SAFETY EVALUATION REPORT  
SOURCE/BYPRODUCT MATERIAL LICENSE  
OGLE PETROLEUM, INC.  
BISON BASIN PROJECT  
DOCKET NO. 40-8745  
LICENSE NO. SUA-1396

MAY 1981

Figure 7. OPI July 18, 1980 submittal.  
Source: OPI July 18, 1980 submittal.

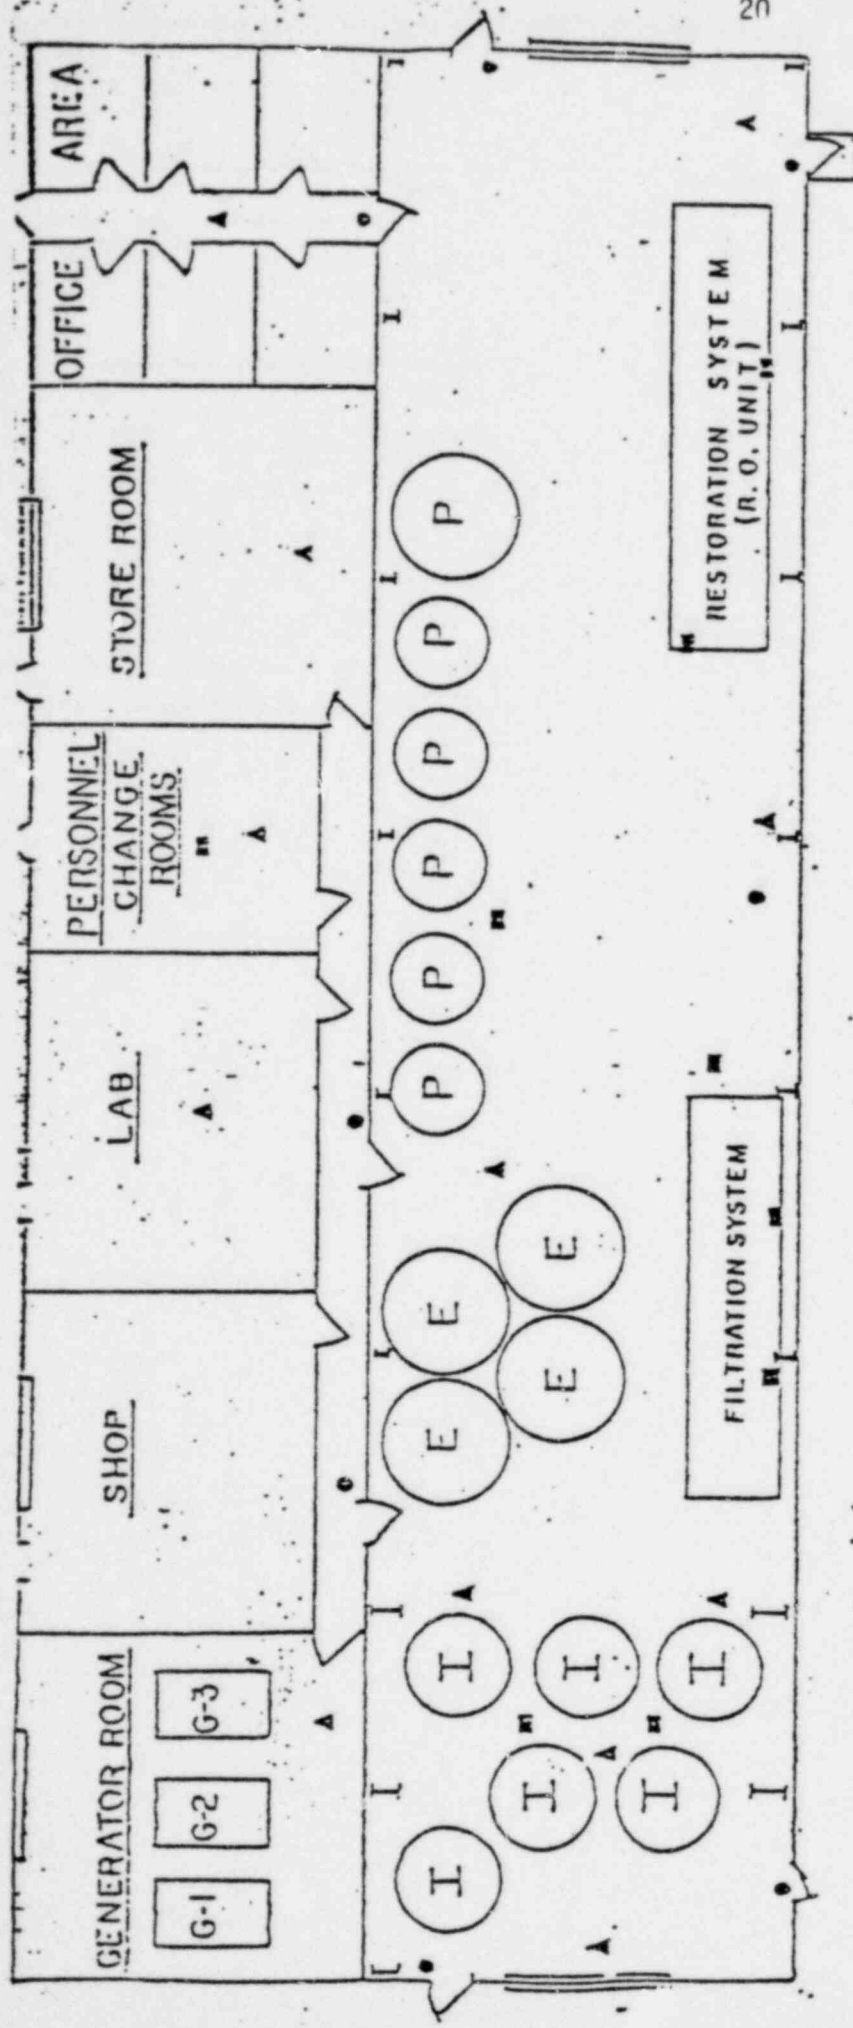
The applicant has proposed to monitor for both radon gas and radon progeny. Radon gas air samples will be collected using scintillation cells near the ion exchange columns where workers may be present and at a total of twelve locations in the process building (see Figure 7). Sampling frequency will be determined

Although NRC regulations permit measurements of concentrations of either radon-222 itself or the radon daughters, the staff considers measurements of the radon progeny to be more appropriate measurements and more relevant in terms of hazard to the worker, as well as being easier to obtain. The staff has concluded that the above sampling locations, methods, and associated sensitivities as presented by the applicant are adequate to determine the concentrations of radon-222 and its progeny. The sampling frequency shall be monthly to provide sufficient data to permit quarterly working level determinations. If radon progeny or radon concentrations are found to exceed 8 pCi/l or 0.08 WL (Working Levels), respectively, surveys shall be performed on a weekly basis. Such weekly sampling shall be maintained until four consecutive weekly samples are less than 8 pCi/l or 0.08 WL. Any changes in the monitoring locations or methods shall require a license amendment.

26. In addition to the In-Plant Airborne Radiation Monitoring Program contained in Section 3.5 of the May 19, 1980 submittal and the July 18, 1980 submittal, the following shall be required. The licensee shall perform surveys for natural uranium on a monthly basis with the exception that it shall be increased to weekly for any restricted area meeting the limits of an "airborne radioactivity area" as defined in 10 CFR Part 20.203(d) and an investigation of the cause of the high levels shall be made. The licensee shall perform monthly surveys for radon or its particulate daughters in all enclosed process structures inhabited by workers. The licensee shall perform radon or radon progeny surveys on a weekly basis if the radon or radon progeny concentrations are found to exceed 8 pCi/l or 0.08 WL (Working Levels) respectively. Such weekly sampling shall be maintained until four (4) consecutive weekly samples exhibit less than 8 pCi/l or 0.08 WL.
